HISTORIC RESOURCES PRESERVATION BOARD REPORT

HRPB Project Number 26-01500001: A request for a variance to allow an 8-foot-high fence along the side alley property line at 338 Cornell Drive. The subject property is a contributing resource within the College Park Historic District and is located in the Single Family Residential (SFR) zoning district. The future land use designation is the Single Family Residential (SFR).

Meeting Date: February 11, 2025

Address: 338 Cornell Drive

Subject fencing at 338 Cornell Drive, 8 feet tall (marked in orange)

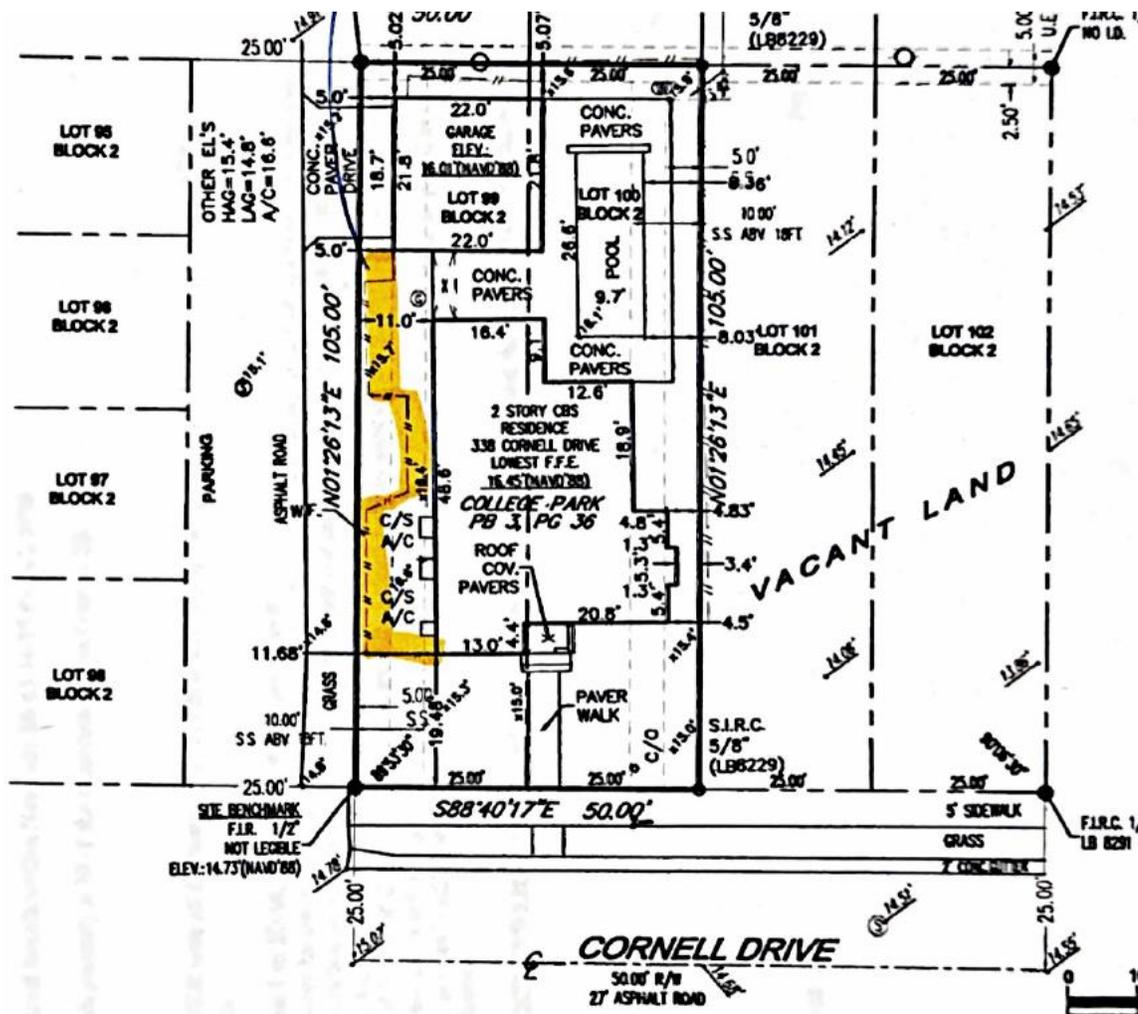
Analysis: The fencing on the west side property line at 338 Cornell Drive conflicts with the requirements in the City's Land Development Regulations, specifically the limitations for maximum fence height alongside property lines.

Per LDR Section 23.4-4(d)(1)(C), the maximum height of fences or walls on the side property line is six (6) feet. While 8' fencing is permitted along alleyways, the code specifies that this applies only to rear property lines. The applicants are proposing approximately 80.5 linear feet of fencing on the west side property line along an alley that measures 8' in height (see survey image below).

Required by Code	Proposed
LDR Section 23.4-4(d)(1)(C): On the rear property line (not adjacent to an alley) and on that portion of the side property line from the rear property line to the front building setback line, a fence or wall shall have a maximum height of six (6) feet from the natural grade of the lot.	Approximately 80.5 linear feet of fencing along the west side property line, with a height of 8 feet
